SERVICE No. 1147 BULLETIN

**INCORRECT TURBOCHARGER CLAMP
SUBSTITUTION**

PA-23-250 (Six Place) Aztec

Figure 1
Turbocharger Clamp Location

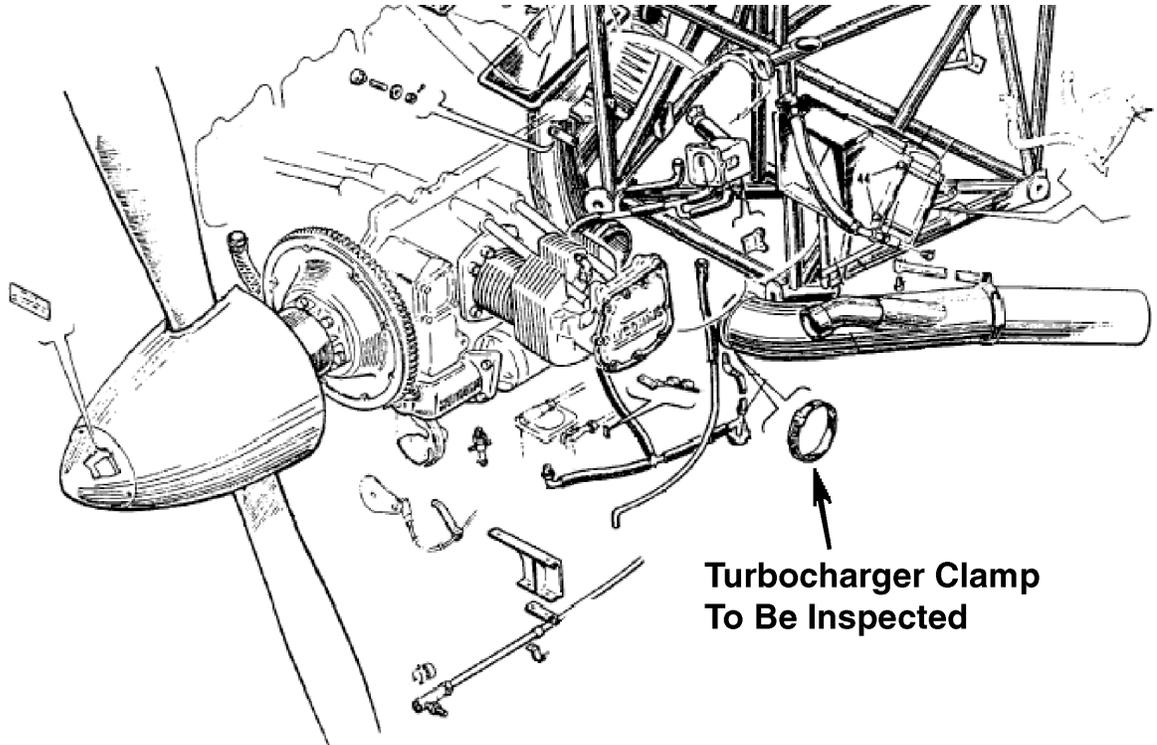
The incorrect clamp (557-584) has a larger nominal inside diameter than the correct clamp (555-511). Installation of the incorrect clamp may lead to hot exhaust gas leakage into the engine compartment that may lead to a fire. This Service Bulletin requires the inspection of aircraft that may have had this clamp replaced for correct part number installation and replacement of the incorrect clamp, if installed, prior to further flight.

1. Remove the engine cowling, as required, (ref. Service Manual 753-564, Section VIII B) to gain access to the turbocharger clamp for inspection (Ref. Figure 1).
2. Inspect the clamp part number to verify correct installation. The part number marked on the clamp should be MVT69861-377.
3. If this part number clamp is not installed on the aircraft, replacement is required before further flight. Order and install Piper part number 555-511 per Service Manual 753-564, Section VIII B.
4. If the correct part number is installed, no further action is required.
5. Re-install the previously removed engine cowling per Service Manual section VIII B.
6. Make a logbook entry indicating compliance with this publication.

MATERIAL REQUIRED: One (1) each, clamp, Piper part number 555-511, per aircraft, if required.
